# MISSOURI 2019 AIRPORT LIGHTING PACKAGE

## WEST PACKAGE

## ADDENDUM NO. 1

November 2, 2020

VAULT ENCLOSURE  
PLAN AND DETAILS

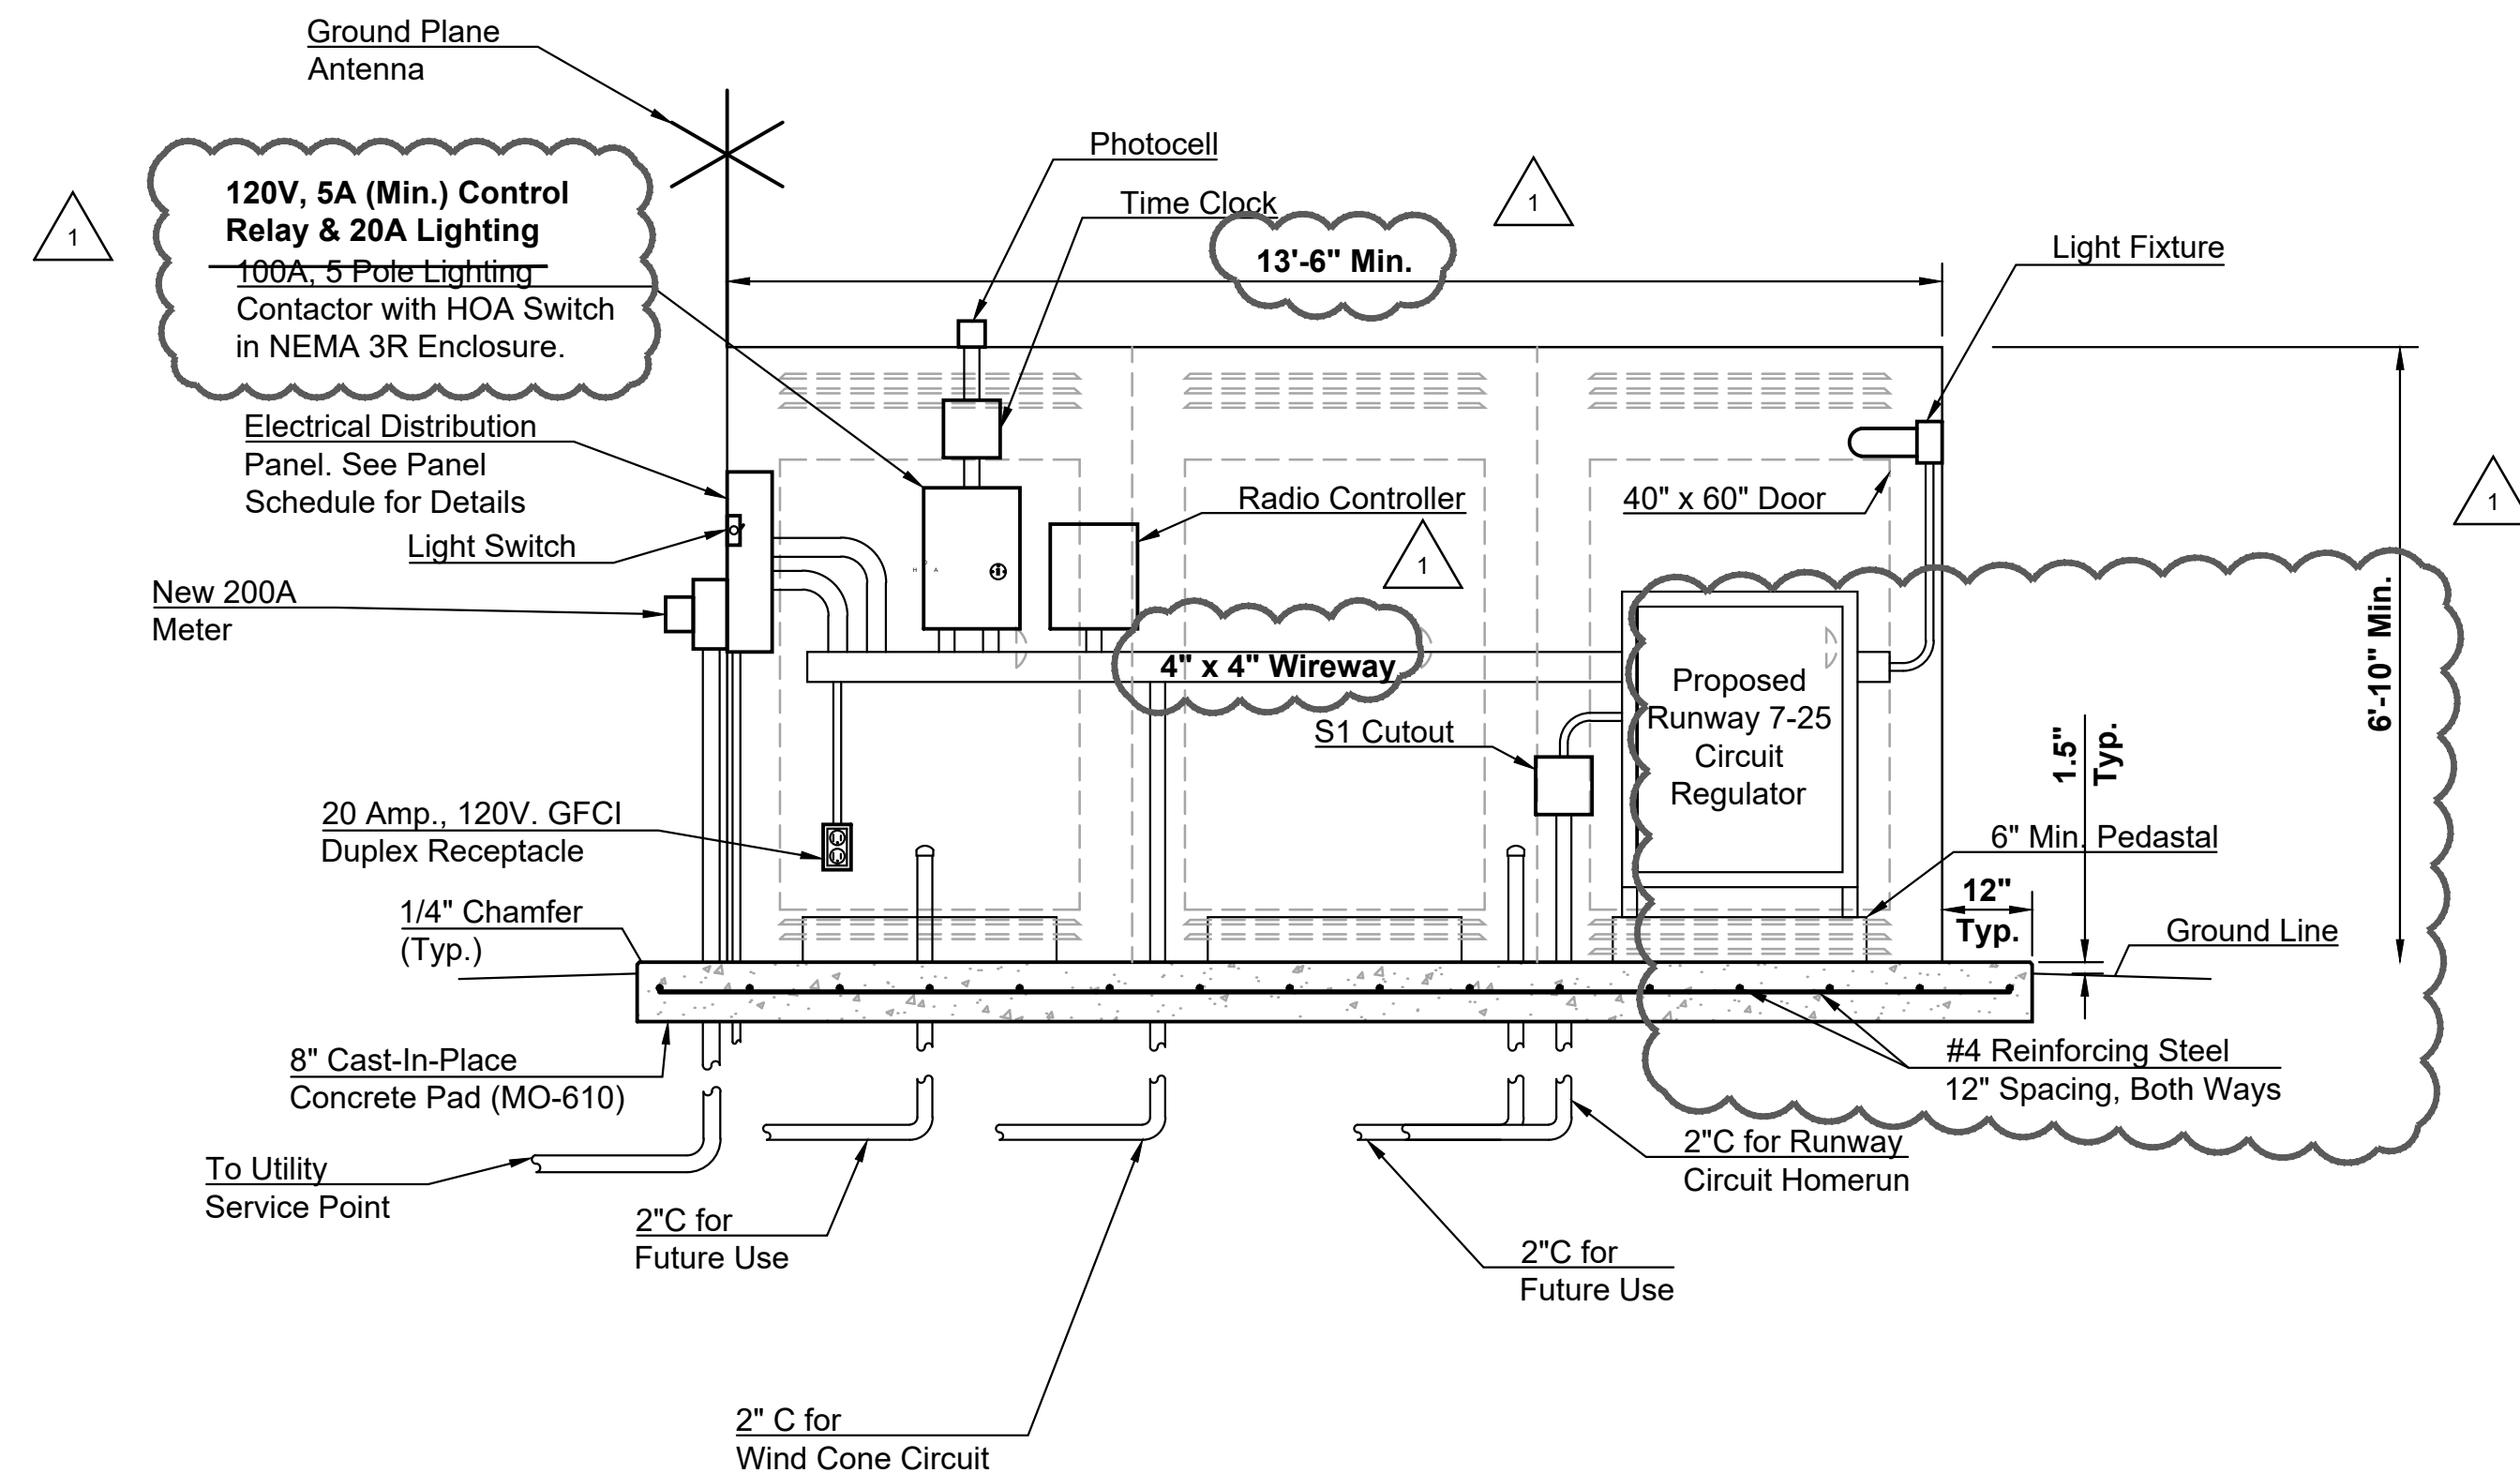
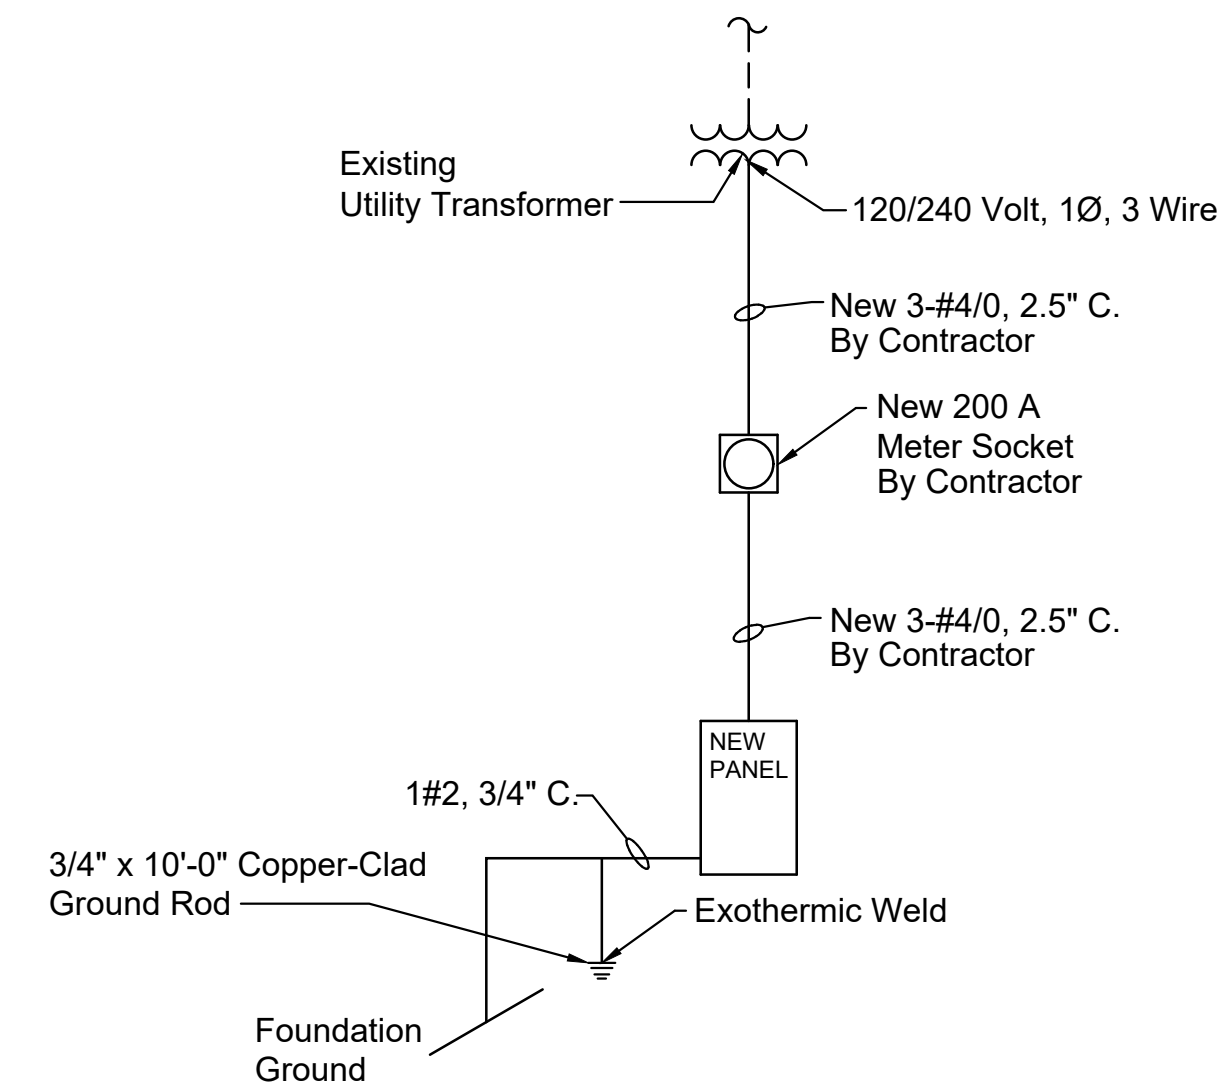
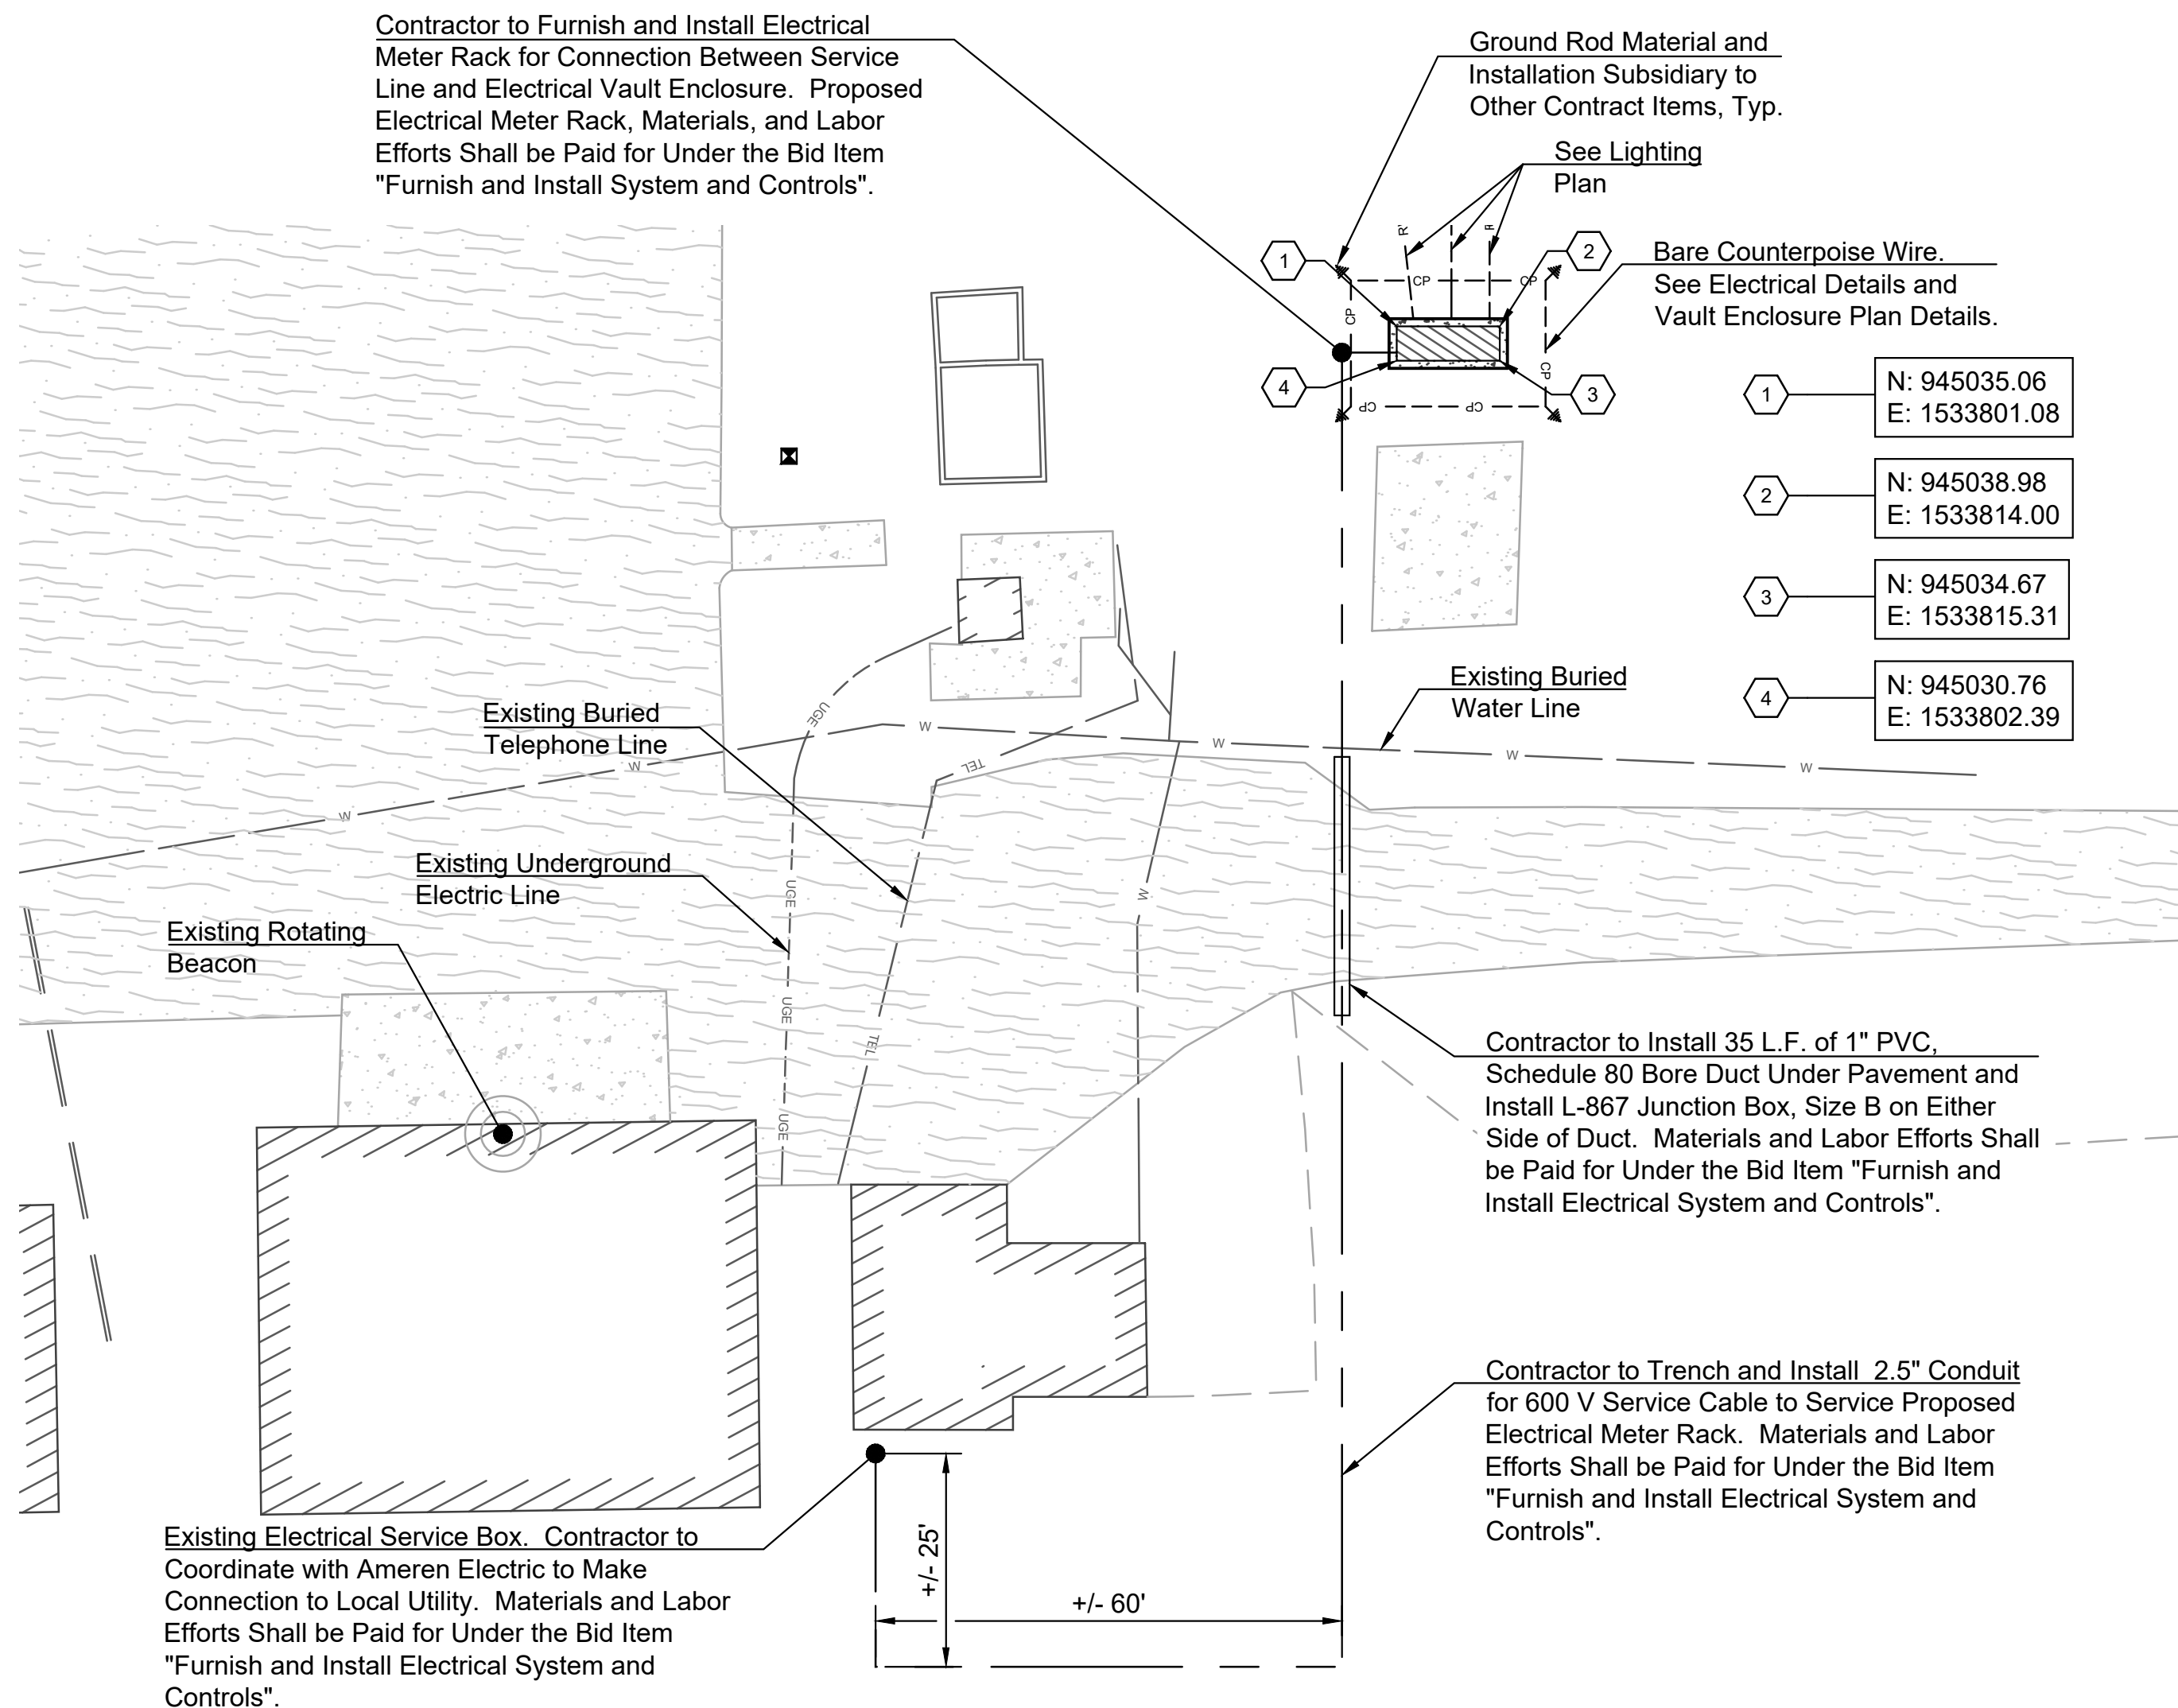
5. **Schedule C: Roy Otten Memorial Airfield**, Sheet No. 12 Vault Enclosure Plan and Details. The 4" x 4" wireway note was added to the drawing. Dimensions for the electrical vault enclosure that were accidentally omitted have been added. The 100A lighting contactor for the regulator and wind cone was removed. The regulator will now be controlled via a 120V, 5A (minimum) control relay and 20A, 2 pole lighting contactor.
